# Service Bulletin

**ENGINE NO START IN EXTREMELY COLD AMBIENT TEMPERATURES**

**Bulletin No:** 01-023/13

2013-2014 CX-5

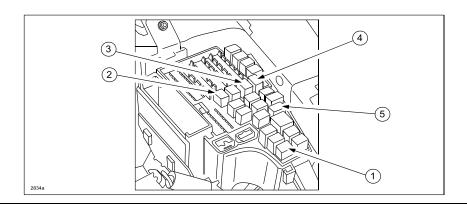
Some vehicles may exhibit an engine no start in ambient temperatures below -4 degree Fahrenheit (-20 degree Celsius) after driving for 10 - 20 minutes and then parking the car for about one hour. This may be caused by the contact point of the main relay freezing due to moisture inside the main relay.

- 1. Verify customer concern.
- 2. Replace the 5 relays shown in the table below.
